Product Change Notification

Product Change Notification: E-20-011899

DEUTSCH DT SERIES, DT13-12PX AND DT15-12PX AND MODS (X = A,B,C,D KEYS). DOCUMENT CLARIFICATION

New Date Code

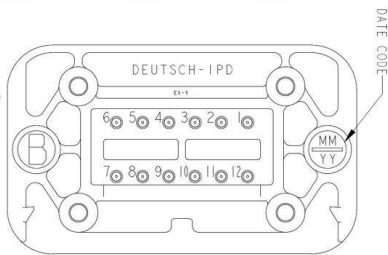
Date Code Chnage

7 DIGIT DATECODE
 YEAR: FIRST AND SECOND DIGITS (16 = 2016)
 MONTH: THIRD DIGIT, EXCLUDING 1. A = JAN., B = FEB., C = MARCH, ... (L = NOVEMBER)
 DAY: FOURTH AND FIFTH DIGITS (10 = 10th DAY)
 HOUR: SIXTH AND SEVENTH DIGITS (14 = 2-3PM)

DT13 Alternate Design

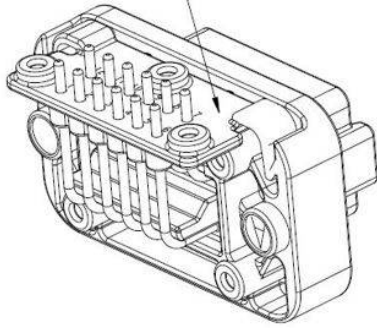
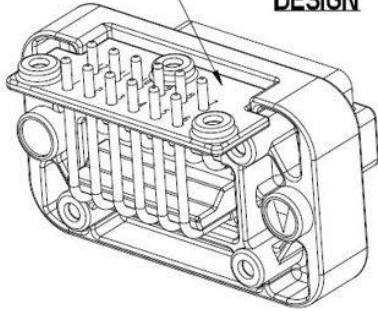
The Industrial and Commercial Transportation business unit of TE Connectivity is adding alternate design view and new date code information on product drawings for the part numbers listed below. Please note that the existing part did not change.

9 SNAP IN PLACE
PIN SPACER

9 WELDED
PIN SPACER

**ALTERNATE
DESIGN**
